Title & Document Type: **8405A Vector Voltmeter Operating and Service Manual**

Manual Part Number: **08405-90024**

Revision Date: **May 1971**

8405A

Figure 7-11(b). Schematic Diagram, Phase Meter

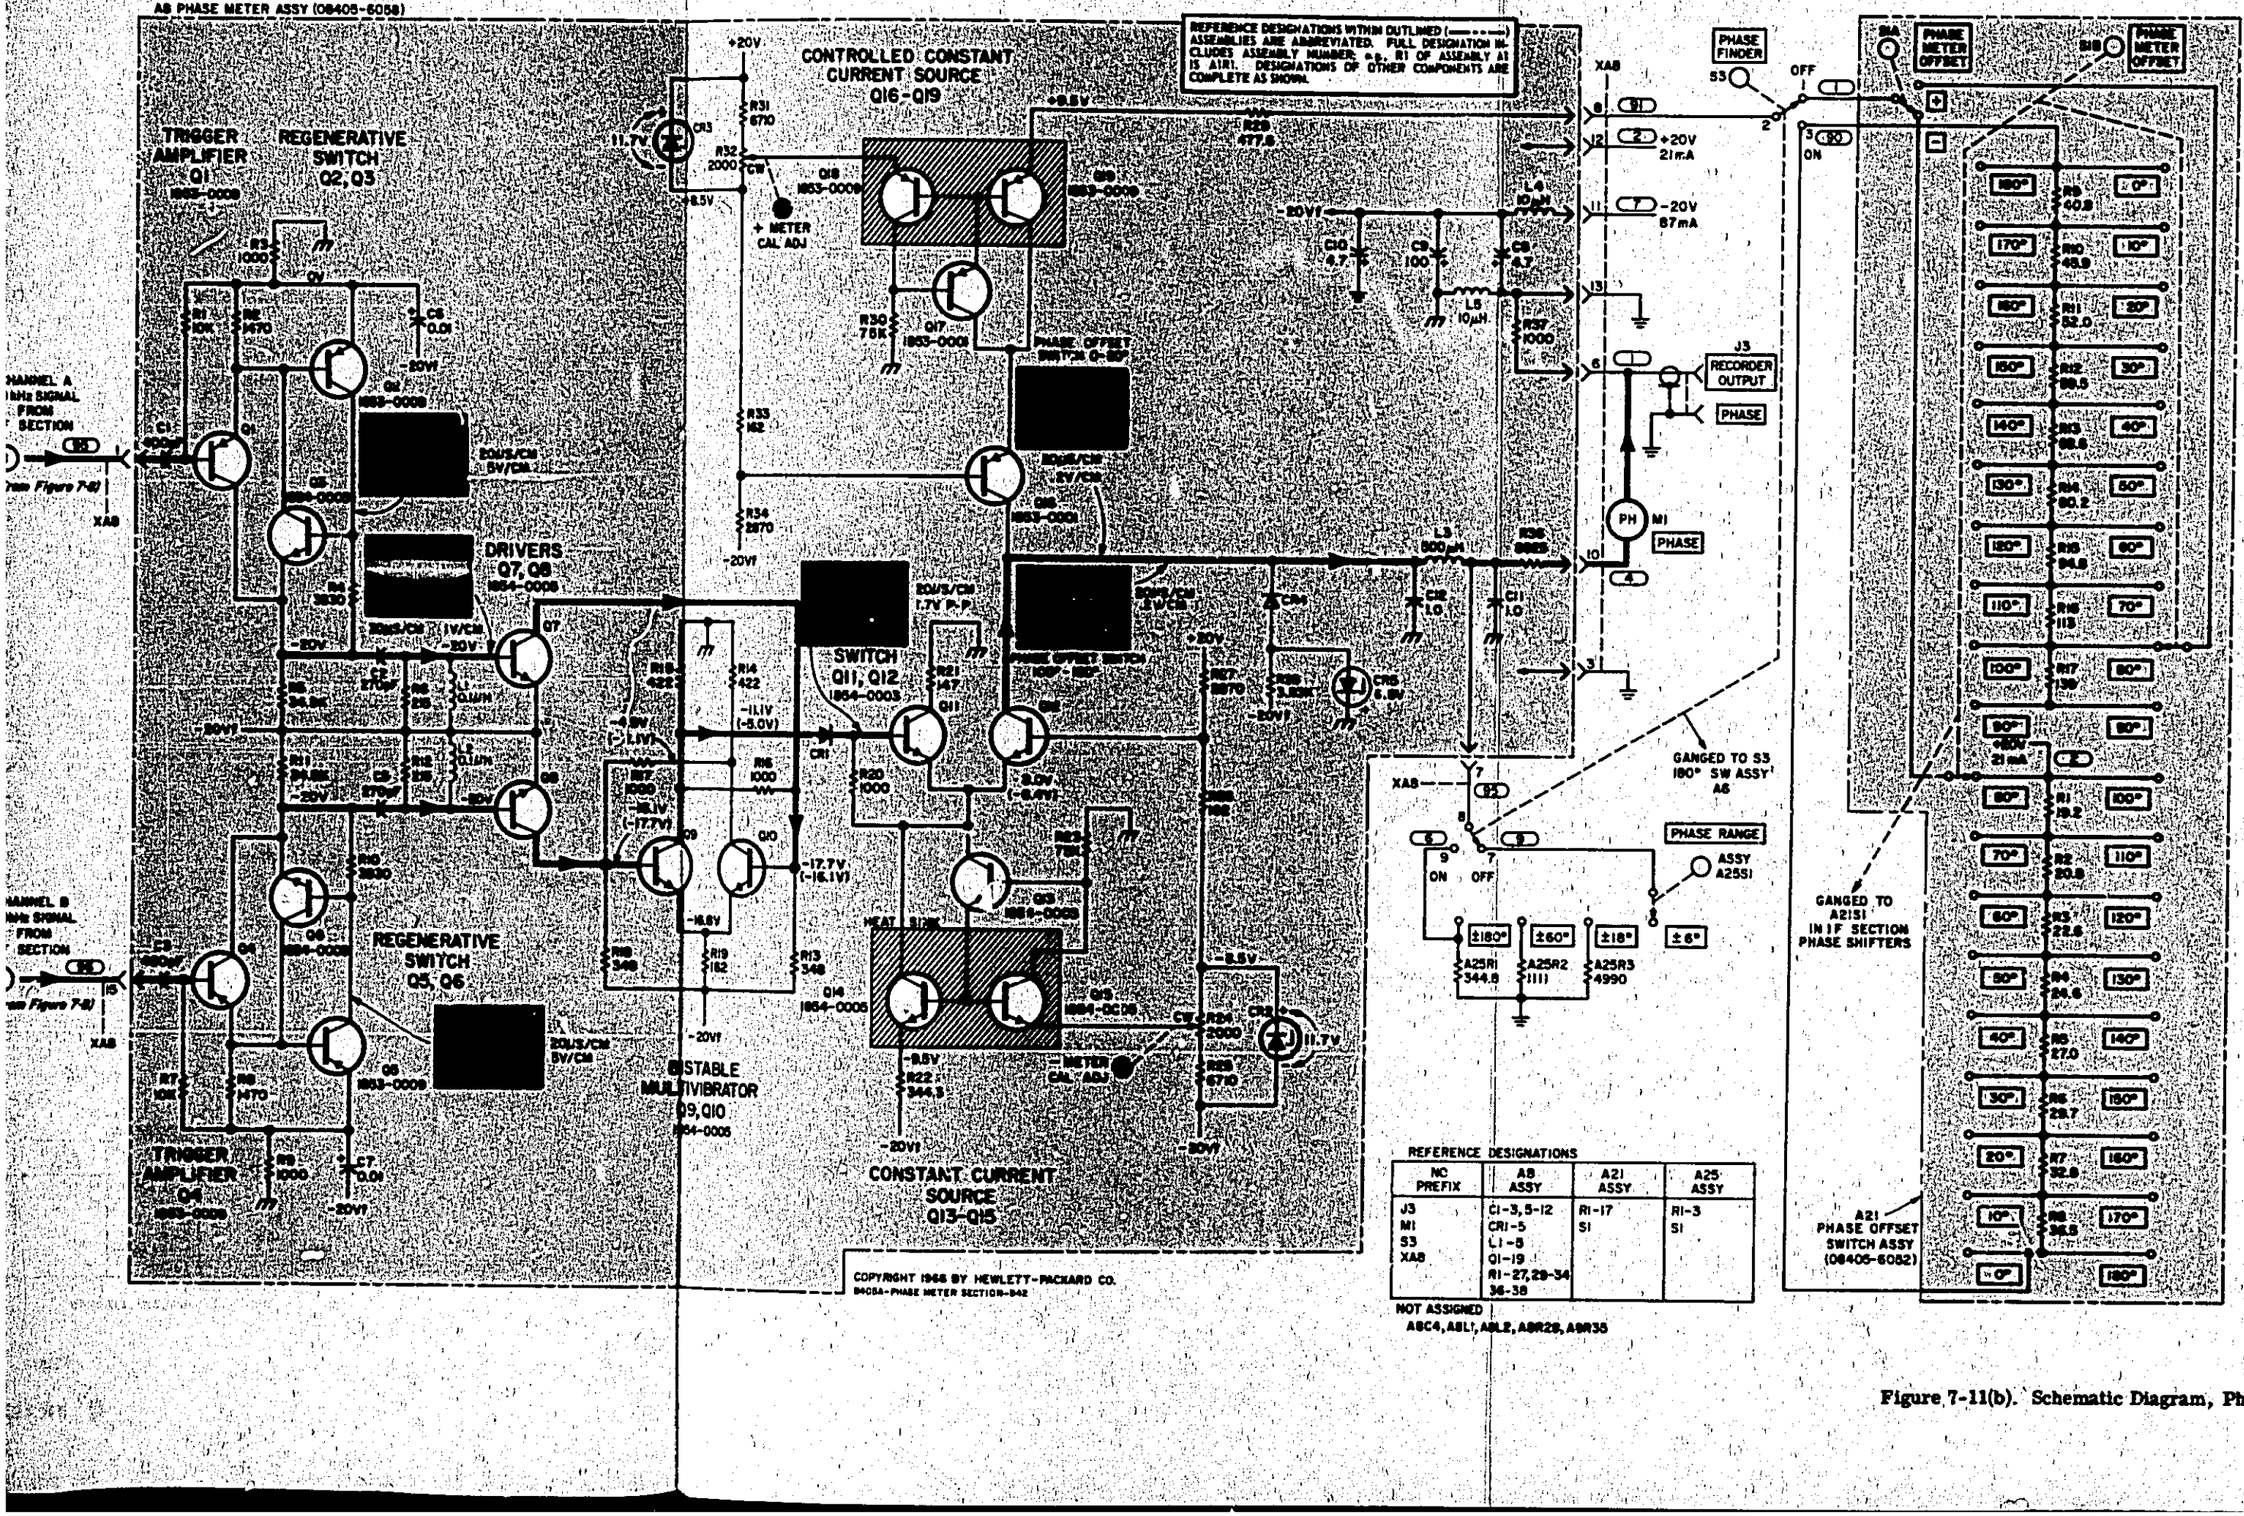
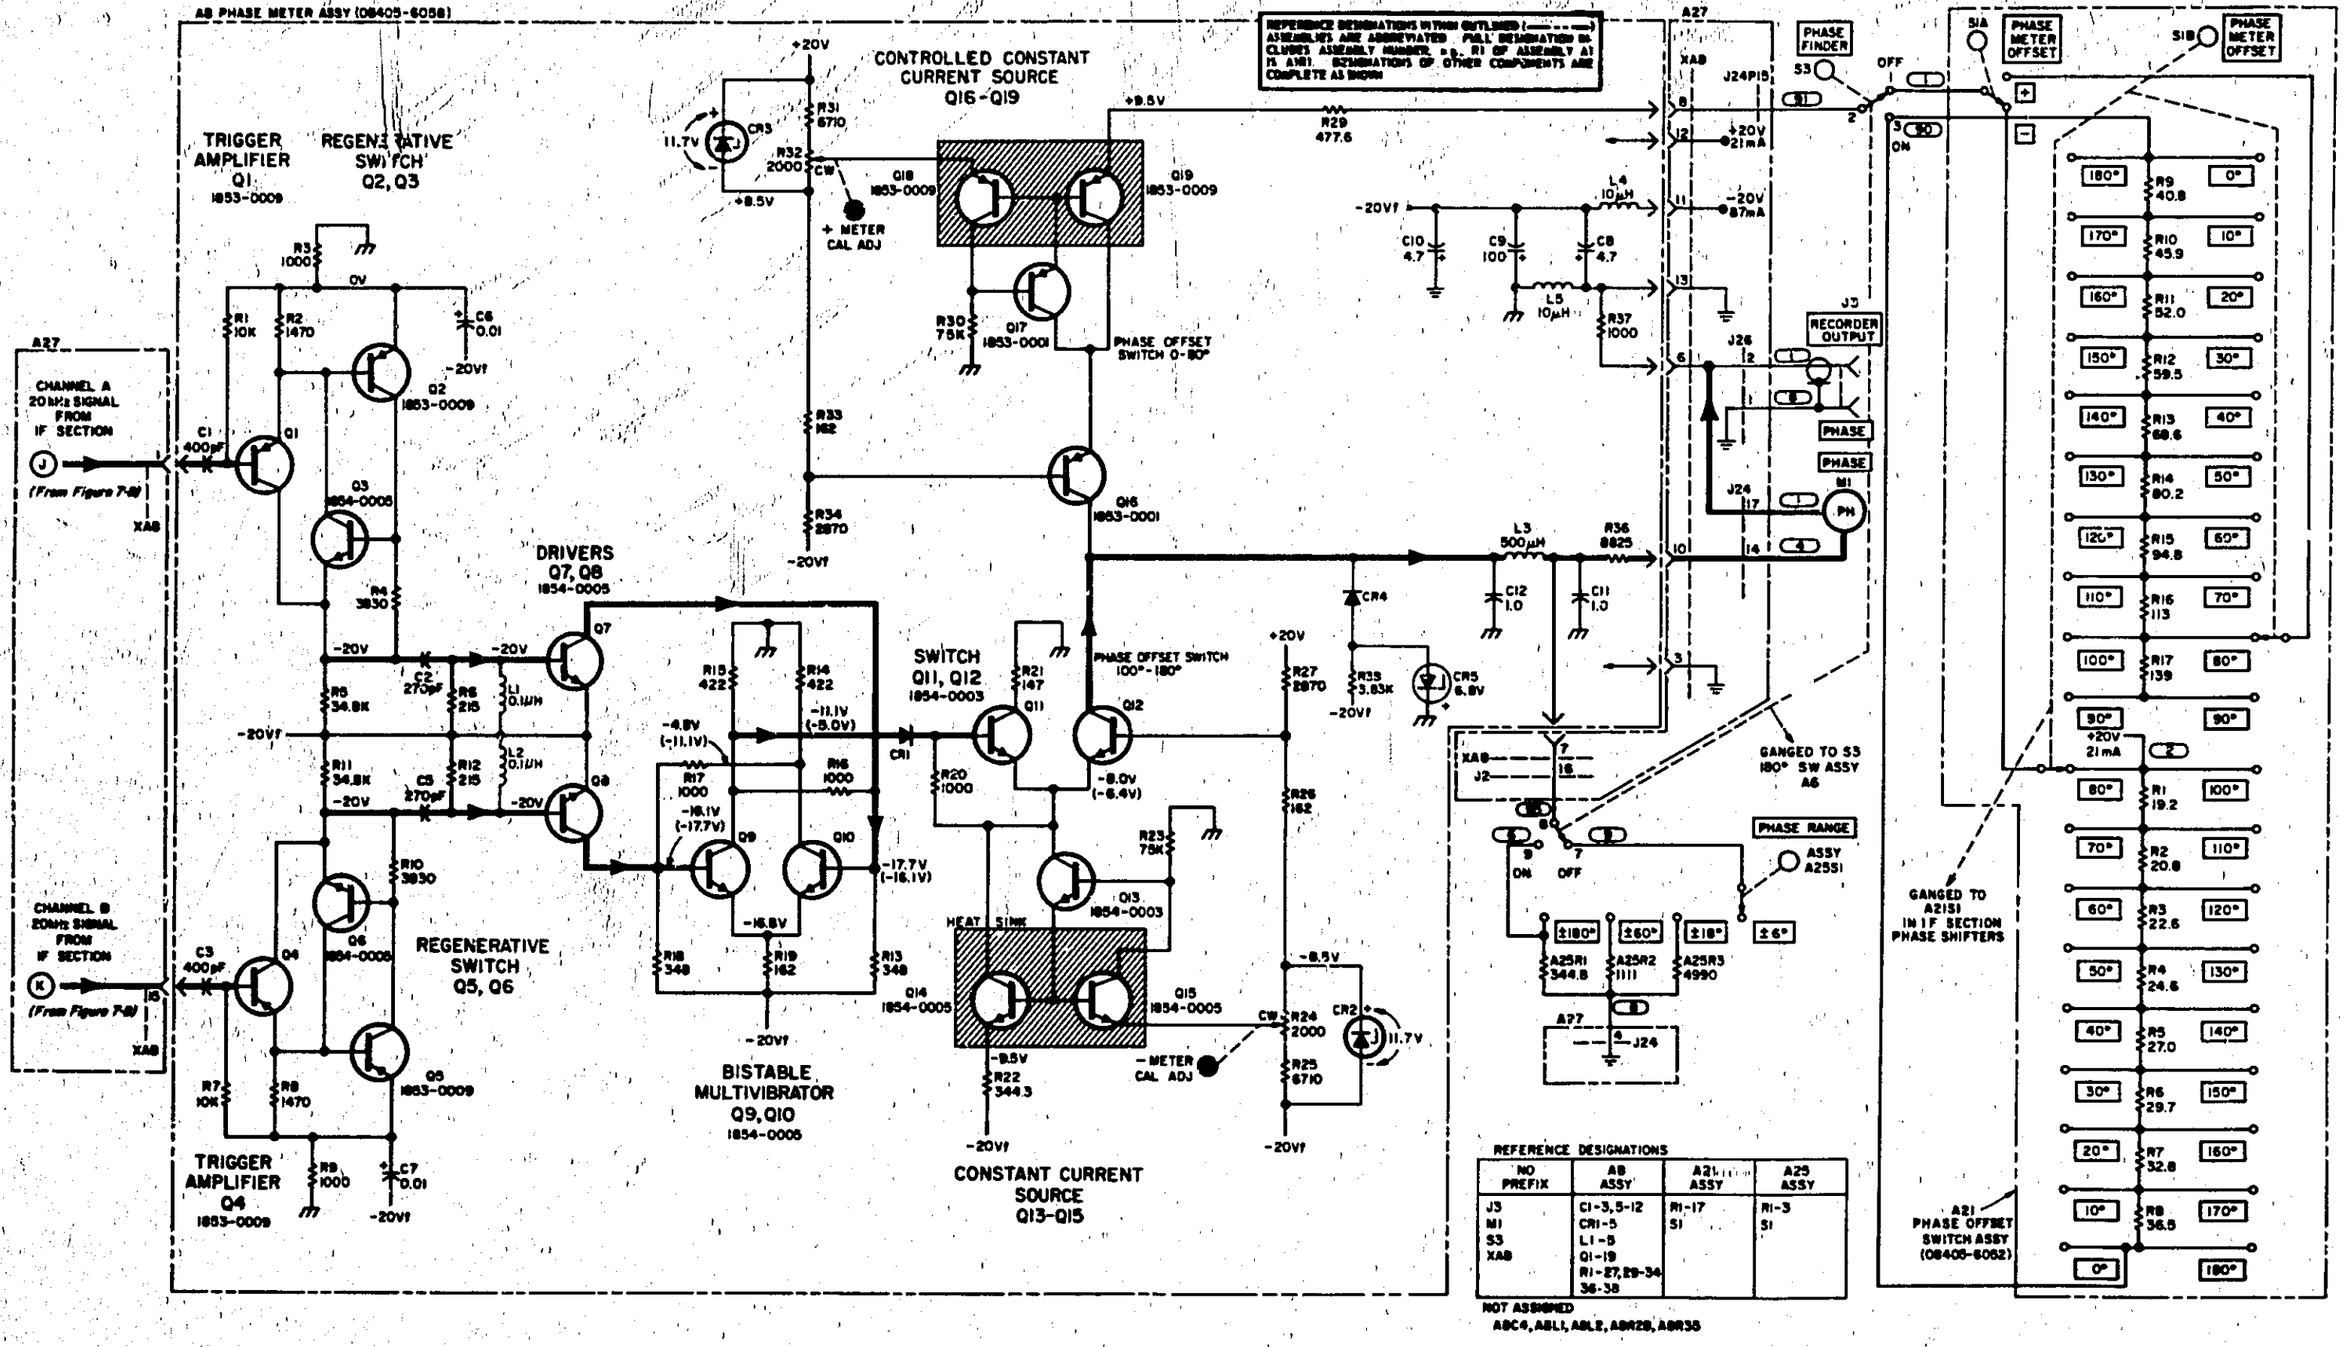
Change Figure 7-11(b) of Change 17. In the lower left corner of the replacement page, the A21 Phase Offset Switch Assy is identified as part number 08405-6052. Replace the part number with this note: See Table 6-1 for current assembly number.

PAGE 7-11:
Figure 7-11(b):
Change Figure 7-11(b) of Change 17. In the lower left corner of the replacement page, the A21 Phase Offset Switch Assy is identified as part number 08405-6052. Replace the part number with this note: See Table 6-1 for current assembly number.

Replace Figure 7-11(b) with Figure 7-11(b) in this document (CHANGE 17).
